Access Compliance Report Public Rights-of-Way (Curb Ramps)

Intersection ID: 10036726 Main Street: S_COLLEGE_ST Cross Street: N/A Location: SE ADA ID: BFD81E10F77E Ramp Type: Perp Initial Pass/Fail: Fail **Overall Compliance: No Severity Score:** 12.5

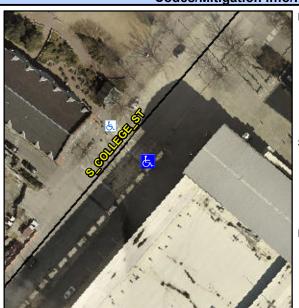
Possible Solutions: Remove & Replace Entire Ramp. Surveyor Notes: N/A PROW/ADA: Not Found, R304.2.2

Field Measurements/Component Compliance								
Comp	liance Description	Data	Comp	liance	Description	Data		
N/A	Ramp Length (in)	64.0	No	Ramp	Slope (%)	9.0		
Yes	Ramp Width (in)	48.0	Yes	Yes Ramp XSlope (%)				
N/A	Flare Type LT	N/A	N/A	N/A Flare Type RT				
N/A	Flare Slope LT (%)	N/A	N/A	N/A Flare Slope RT (%)				
N/A	Flare Traversable LT?	N/A	N/A	Flare	Traversable RT?	N/A		
N/A	Landing Length (in)	N/A	N/A	DWS	Provided?	N/A		
N/A	Landing Width (in)	N/A	N/A	DWS Contrast?		N/A		
N/A	Landing Slope (%)	N/A	N/A	DWS	Length (in)	N/A		
N/A	Landing X Slope (%)	N/A	N/A	DWS	Full Width?	N/A		
N/A	Landing Curb? (Y/N)	N/A	N/A	DWS	Offset (in)	N/A		
N/A	Shared Landing?	N/A						
N/A	Gutter Ponding?	N/A	N/A	Gutte	r Slope (%)	N/A		
N/A	Gutter Lip Ht (in)	N/A	N/A	Gutte	r X Slope (%)	N/A		
N/A	Painted X Walk1?	Yes	N/A	Paint	ed X Walk2?	N/A		
	X Walk 1 Direction	To NW		X Wa	lk 2 Direction	N/A		
N/A	X Walk 1 Width (in)	115.0	N/A	X Wa	lk 2 Width (in)	N/A
